CA 263-07 Donelly Steffan, LLC
VAR 07-3431

May 23, 2007

Re: Variance 07-3431 Donnelly Steffan, LLC

GRADING, SEDIMENT & EROSION CONTROL PLAN
HARBOR SQUARE ~ PHASE 1
 SOLOMONS TOWN CENTER ~ PARCELS 28 & 29
 14532 & 14538 S. SOLOMONS ISLAND ROAD
 FIRST DISTRICT, CALVERT COUNTY
 SOLOMONS ISLAND, MARYLAND 20688
 FOR: SOLOMONS ONE

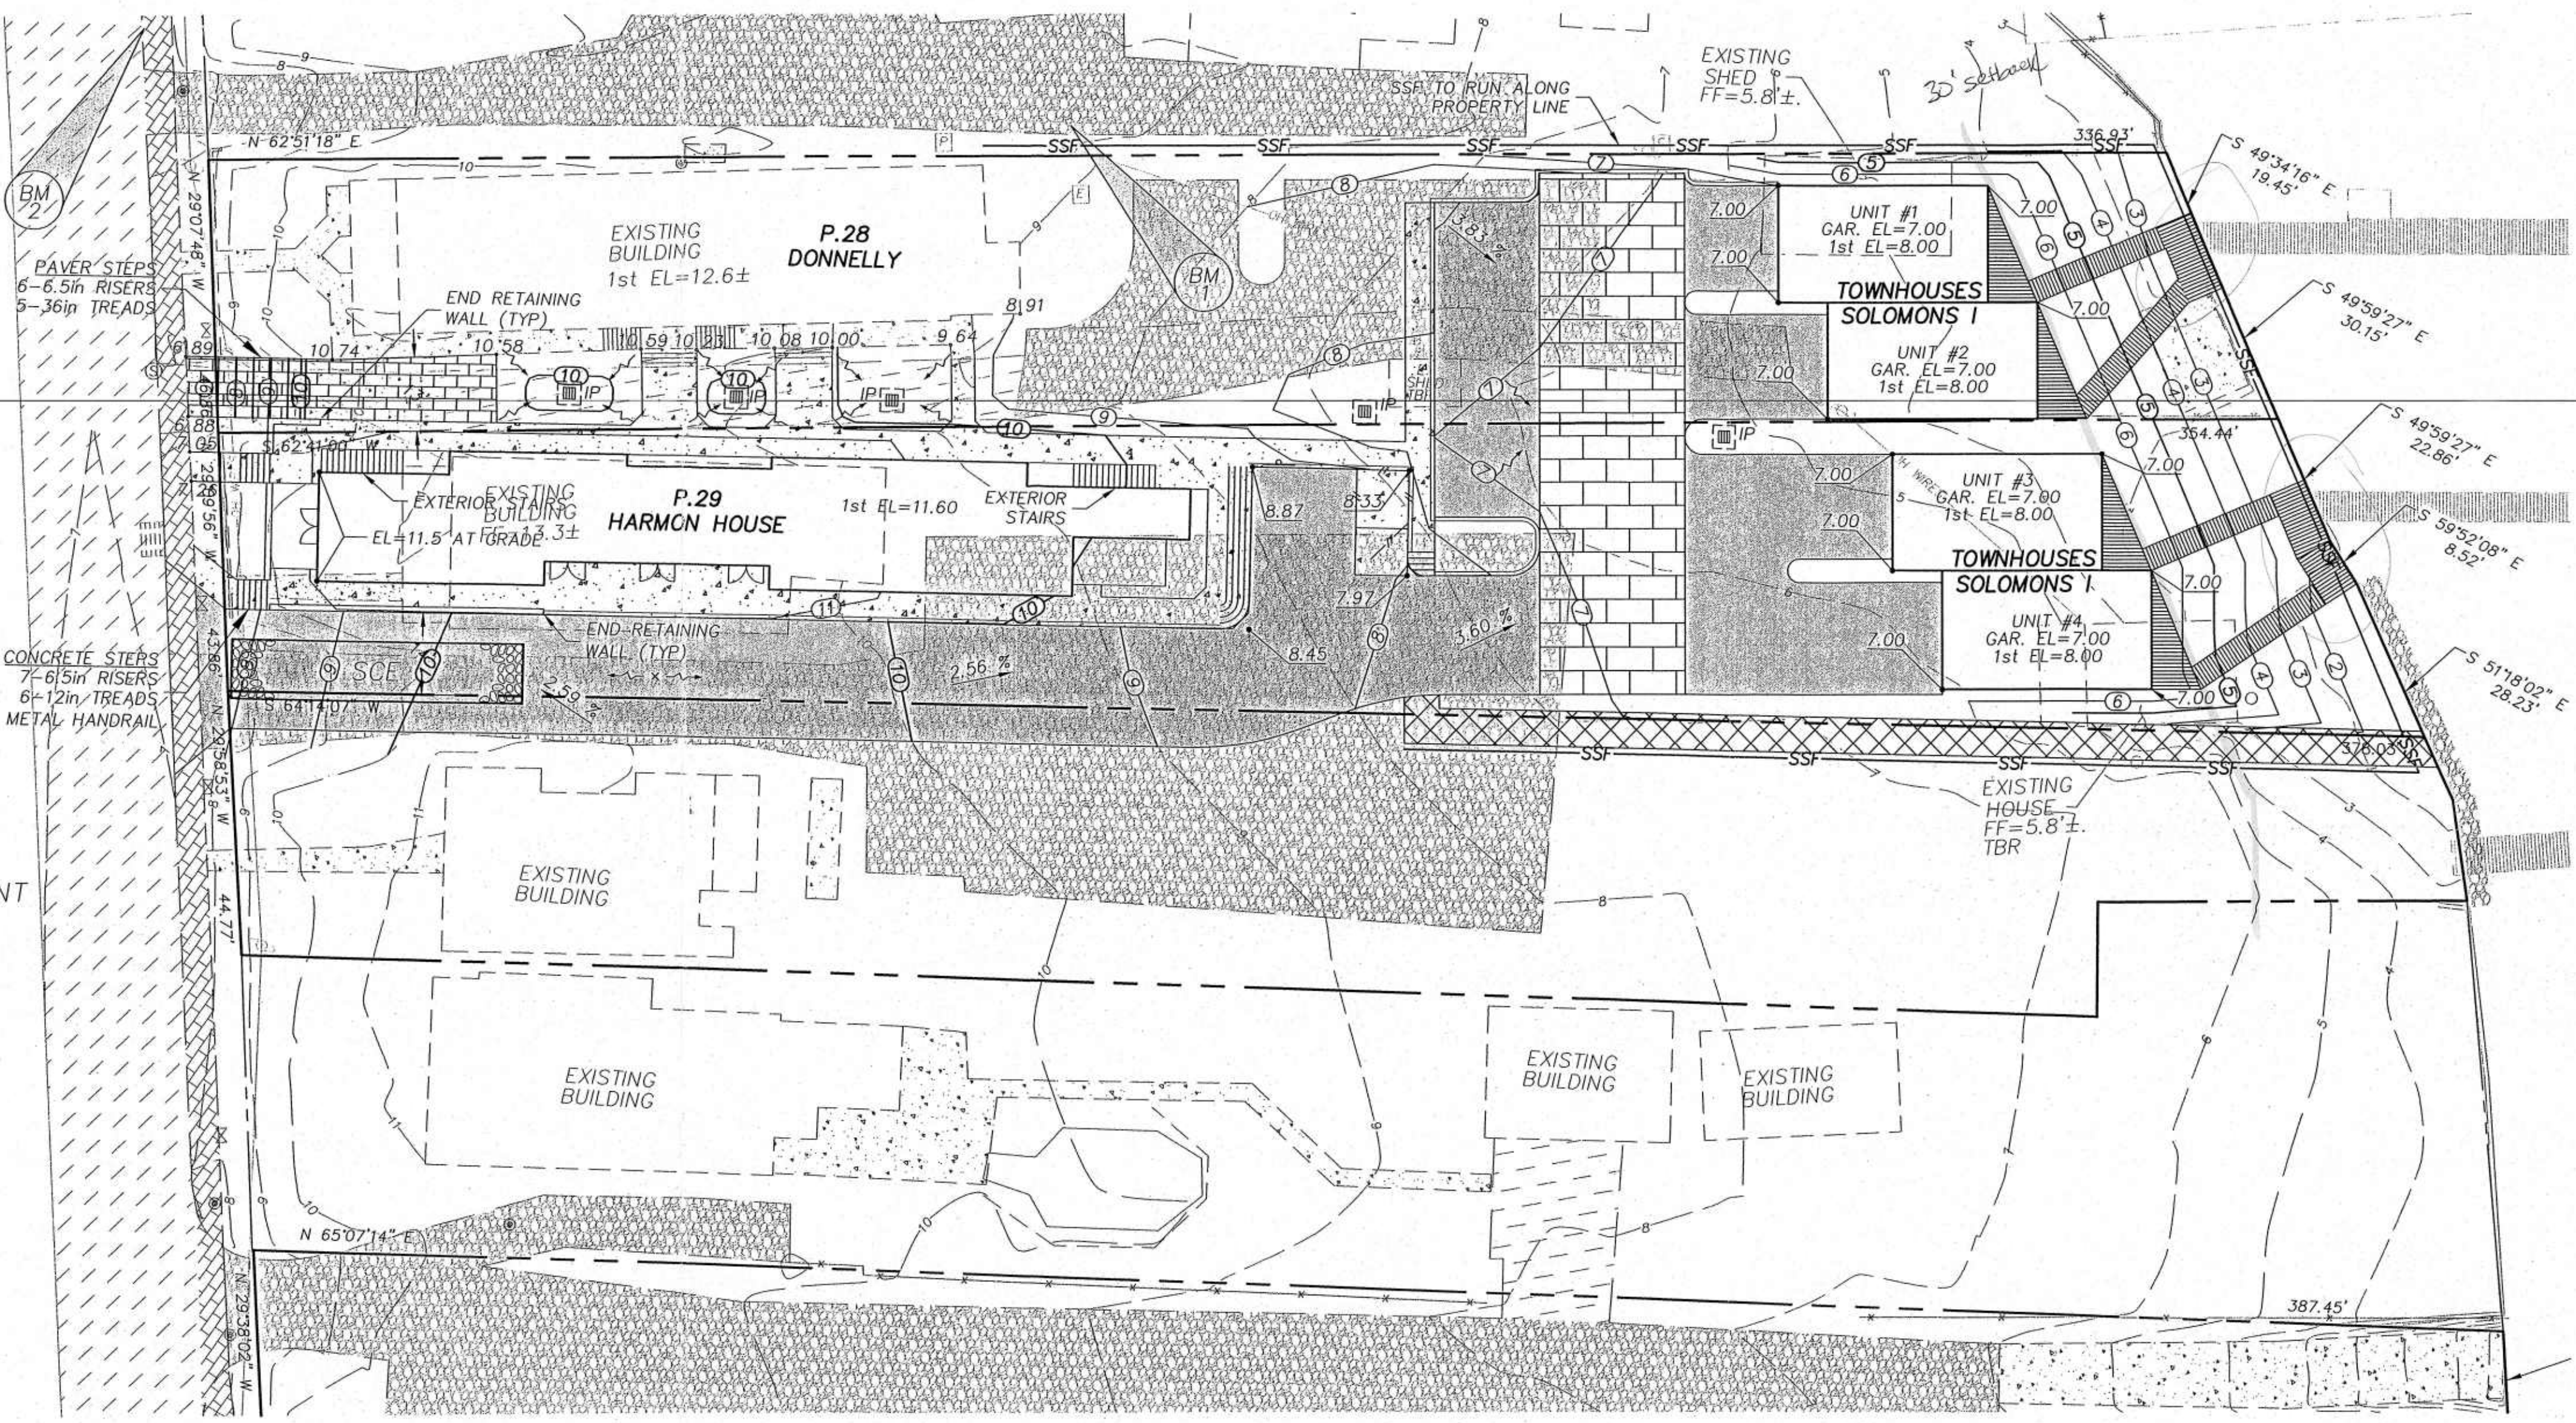
1. The Calvert County Zoning Ordinance (Section 8-1.08.D.3.b) permits one four-foot wide access per waterfront lot through the Buffer. We recognize that the existing property consists of two parcels of record, with two existing piers. As the property is being developed as one project with four townhome units, one access point would appear to represent the minimum necessary disturbance through the Buffer. However, should the Board wish to provide greater flexibility to the property owners given the existence of two existing parcels of record, the provision of a maximum of two access points would appear consistent with the intent and spirit of the County Code. We assert that the four proposed walkways significantly exceed the minimum necessary to provide reasonable access to four townhome units.

2. The existing 30-foot SBMA area is grassed and level. There does not appear to be any justification or any need for the applicant to grade and fill within the SBMA setback, thereby raising the elevation within the existing setback. While the townhome units may require elevation in order to comply with floodplain regulations, there appears ample room to move the units further back towards Solomon's Island Road and to keep all grading outside of the 30-foot setback. The current proposal creates significant potential for adverse impacts to water quality. In addition, there does not appear to be a hardship associated with the lack of grading within the SBMA setback.

3. The proposed decks located parallel to the shoreline are entirely inconsistent with the intent and goals for management of the 30-foot SBMA setback. As previously mentioned the existing SBMA area is level and grassed. The Board's denial of these features would not appear to represent an unwarranted hardship to the applicant as reasonable and significant use of the property would still exist. Further, the award of a variance for these structures would represent a special privilege to the applicant that the Board has previously denied to other applicants and would create the potential for additional adverse impacts to water quality and habitat in the SBMA.

In summary, it is our view that the Board should permit only the minimum necessary walkway(s) through the SBMA setback in order to provide reasonable access to the existing piers. We believe that the applicant has failed to meet the standard of unwarranted hardship in conjunction with the request for four walkways. In regard to the proposed grading, fill, and decks within the SBMA setback, we believe that the applicant has failed to meet each and every one of the County's variance standards. Therefore, we recommend that the Board deny the applicant's request for these improvements.

2. The granting of the 30' Critical Area Buffer variance is contingent upon only one four-foot walkway for waterfront access being provided for each of the Parcels.

3. The applicant is required to intensively replant the buffer with native vegetation for purposes of treating and attenuating stormwater, improving the quality of the tidal waters, and providing for additional habitat.
